Final Environmental Impact Report

San Bernardino County Overnight Solar Project

SCH No. 2024010434

2.0 COMMENT LETTERS AND RESPONSES TO COMMENTS

**Figure 3.3-5. Burrowing Owl Survey Results**

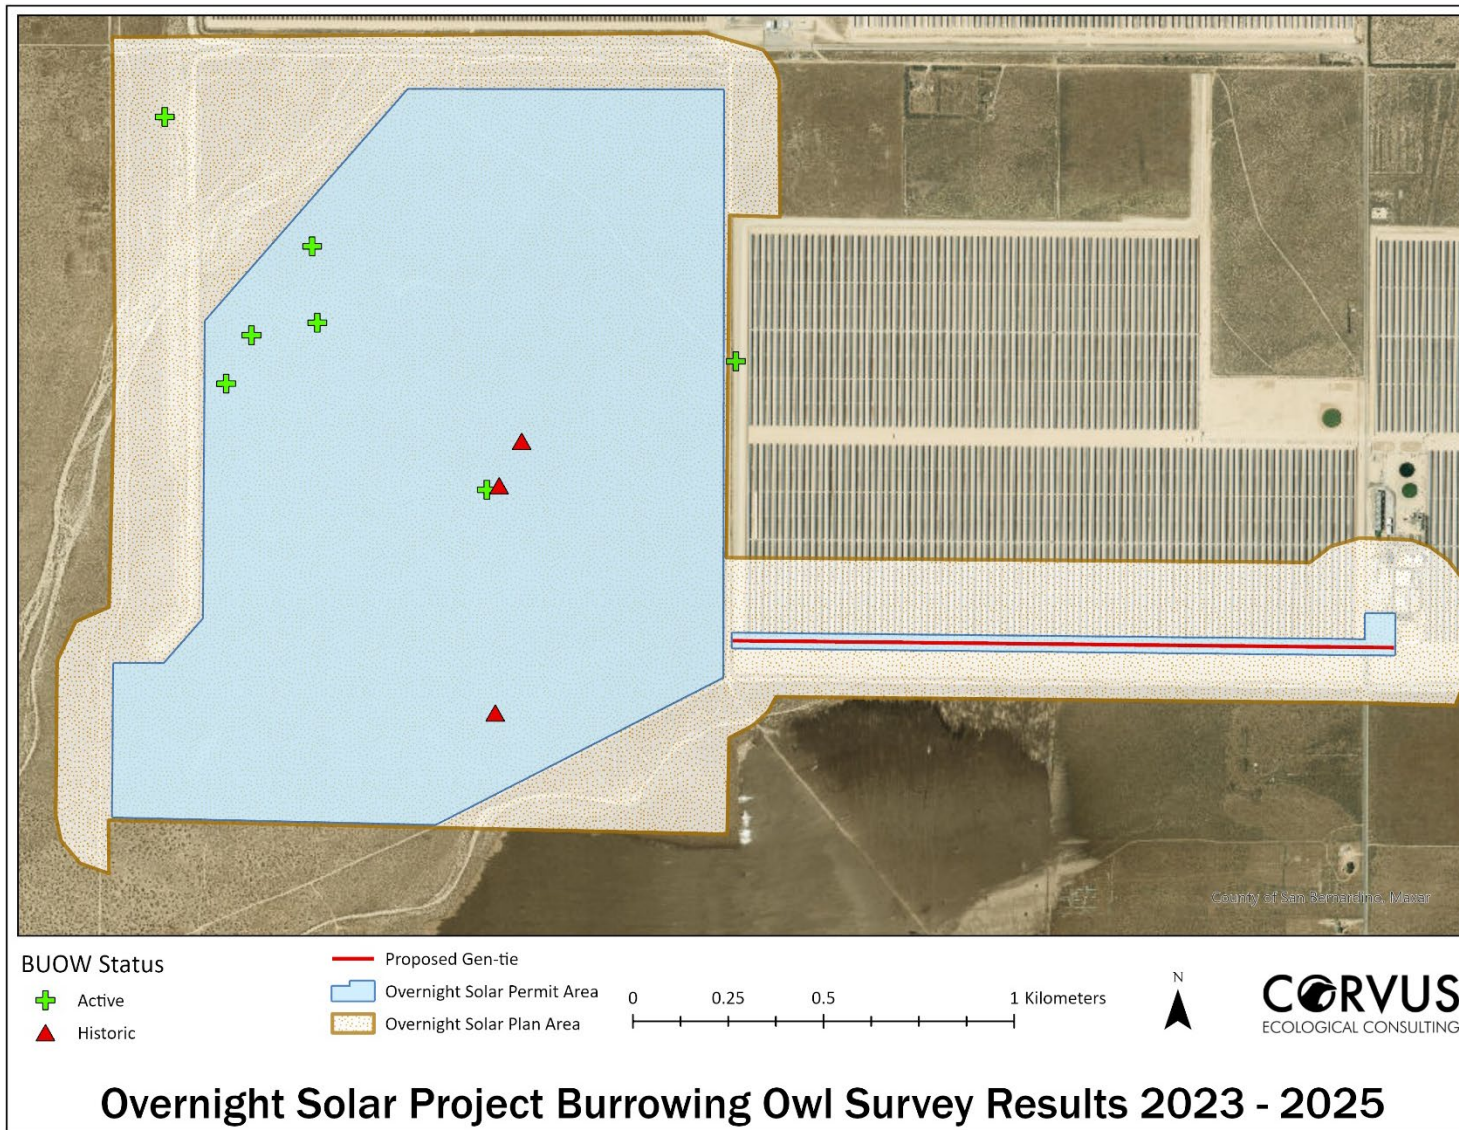
This species was observed within the project ~~site~~survey area. Biologists detected seven live desert tortoises ~~in~~on the project sitesurvey area between April and May 2023, one of which was a juvenile (**Figure 3.3-3**).

Initial burrowing owl surveys were conducted during peak breeding season in 2023 (April 15 to July 15), with two biologists walking 10-meter belt transects across the original survey area. Biologists examined natural and artificial substrates for occupation by western burrowing owl, and recorded signevidence of use (i.e., feathers, pellets, burrows, whitewash, egg fragments, live animals/breeding pairs, and live birds). Biologists marked all occupied and suitable burrowing owl burrows during this effort. During May 2023, ~~and April 2024, and March 2025,~~ all suitable western burrowing owl burrows were revisited in an effort to determine occupancy and site use. Additional western burrowing owl focused surveys were performed in May, June, and July 2024, within the current project site and a 150-meter buffer. The proposed gen-tie corridor was surveyed for burrowing owl on March 26, 2025. Signs of burrowing owl use were considered “historic” if detected within 2023 or 2024 and “active” if detected within 2025. No live Three historic signs and five active signs of burrowing owls use were have been observed within the current project footprint, one active sign of burrowing owl use has been observed northwest of the project footprint, and one active sign of burrowing owl use has been observed within the Mojave Solar Facility (Figure 3.3-5); however, evidence of their presence was recorded in the form of active soil burrows, scat, and pellets (Figure 3.3-3). The occupied burrowing owl burrow within the 150-meter buffer of the current project footprint within the existing Mojave Solar Facility, was detected more than 875 meters from the proposed project gen-tie located in the facility (Figure 3.3-5). However, no signs of burrowing owl use were observed along the proposed gen-tie corridor within Mojave Solar Facility during the 2025 surveys. For these reasons, western burrowing owl is ~~assumed-determined~~ to be present within and around the project footprintsite.

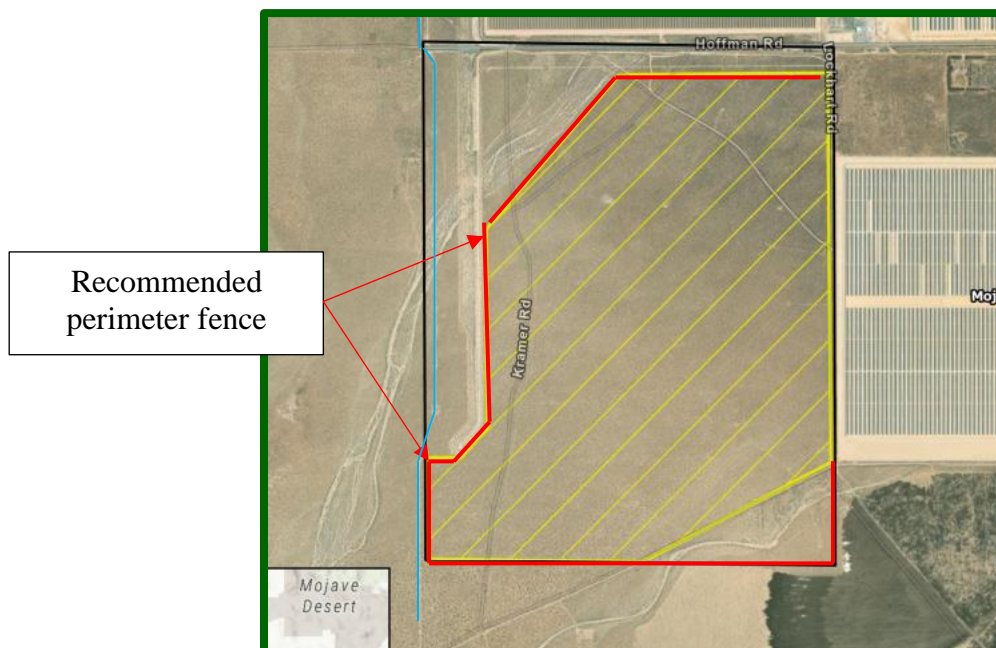
Please be sure the Draft EIR addresses current aquifer characteristics and how this project, combined with the other existing and proposed solar projects, including the Desert Breeze solar project, may affect the aquifer. Our relatively more pertinent concern with the use of so much water is the attraction of known predators, including common ravens and coyotes, into the project area, potentially increasing depredation of tortoises in adjacent areas. Panel washing and dust suppression if not applied in a conscientious manner will result in water puddling onsite and runoff into adjacent areas, which are both human-subsidized water sources for these predators.
